U.S. Department of Transportation

Federal Highway
Administration

Refer to: HNG-14

This is in response to your December 13, 1989, letter to Mr. Thomas O. Willett requesting acceptance by the Federal Highway Administration (FHWA) of your company's aluminum slipbase luminaire support for use on Federal-aid highway projects. A test was conducted to assess the compliance of the base with FHWA breakaway requirements, which cite Section 7 of the 1985 American Association of State Highway and Transportation Officials' (AASHTO) Standard Specifications for Structural Supports for Highway Signs, Luminaires and Traffic Signals. You enclosed for our review a Southwest Research Institute report (Project No. 06-3116-503), dated November 1989, containing results of the pendulum test on an aluminum pole with this base design. Further information, including a film of the test, was transmitted with your letters of January 12 to Mr. Nicholas Artimovich and April 25 to Mr. Willett.

ALTERATIONS	MATERIAL	P&K POLE PRODUCTS
A 15" WAS 13-50 10/24/89	HRS - 1020	84 FOUNDRY STREET, NEWARK, N.J.
	375' THICK	FOUNDATION PLATE,
	FINISH OR TEMPER HOT DIP GALV.	SLIP BASE
		WRB 7/20/89
		B-96307
		REV. A

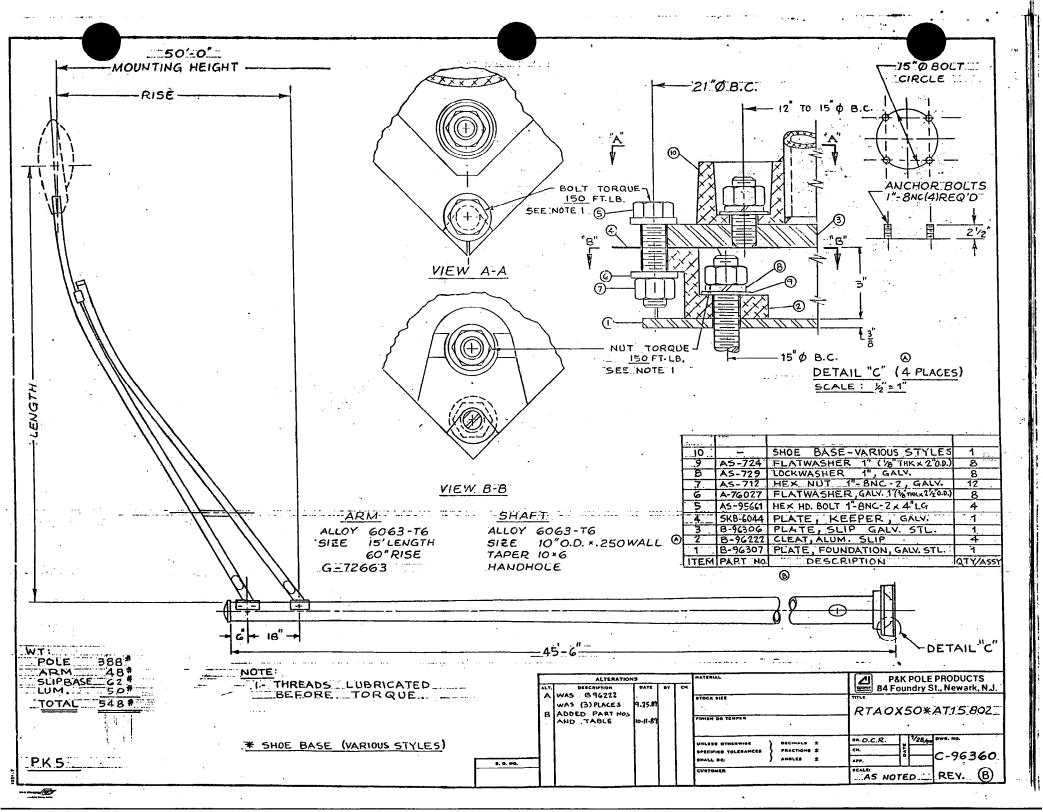
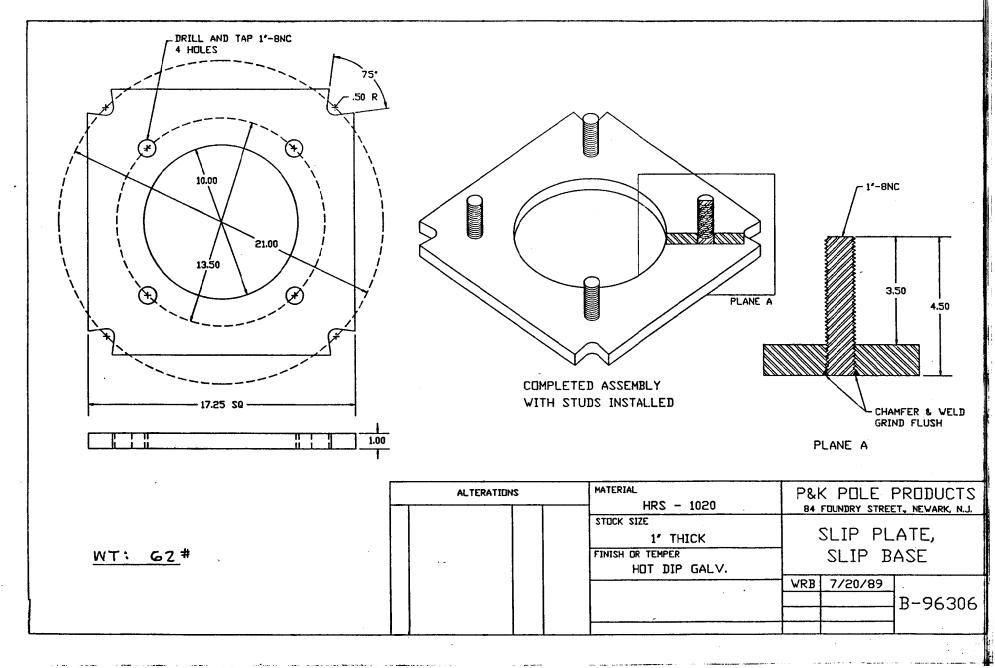
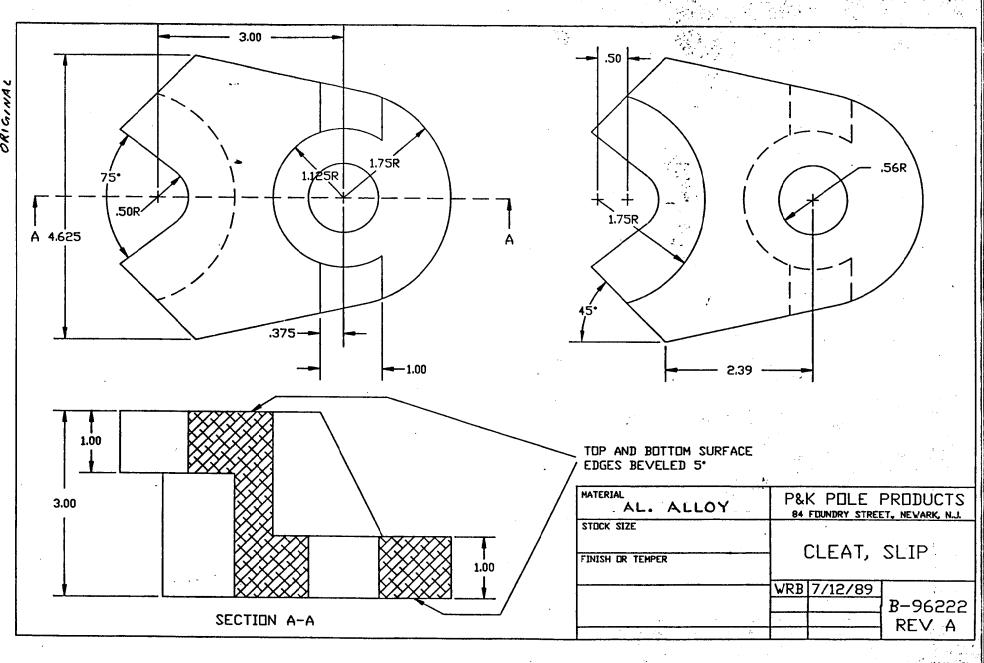
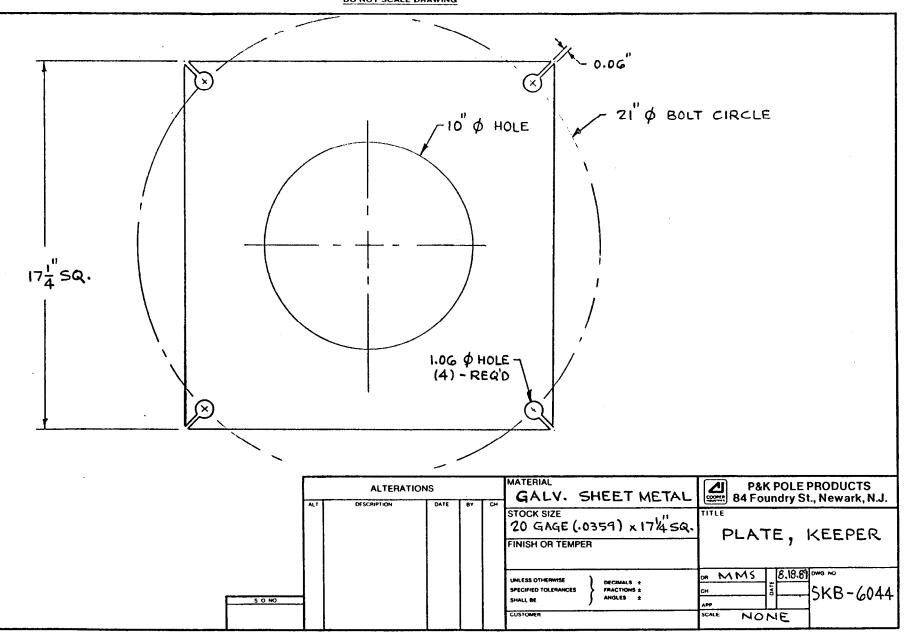
This information shows that the tested pole-base combination will meet the change in velocity and stub-height requirements adopted by the FHWA.

Thus, your company's aluminum slipbase for 10-inch 0.D. supports, with maximum support and luminaire weights of 575-pounds and minimum pole wall thicknesses of 0.250 inches, when installed as shown on the enclosed drawings, is acceptable for use on Federal-aid highway projects, if proposed by a State. This acceptance is limited to breakaway characteristics of the base and does not cover its structural features. Presumably, you will supply potential users with sufficient information on structural design limitations, including resistance to torsion and overturning, and on installation requirements to ensure proper performance. We anticipate that the States will require certification from P & K Pole Products that the bases furnished have essentially the same chemistry, mechanical properties, and geometry as the base used in the test, and that supports with those bases will meet the FHWA breakaway requirements.
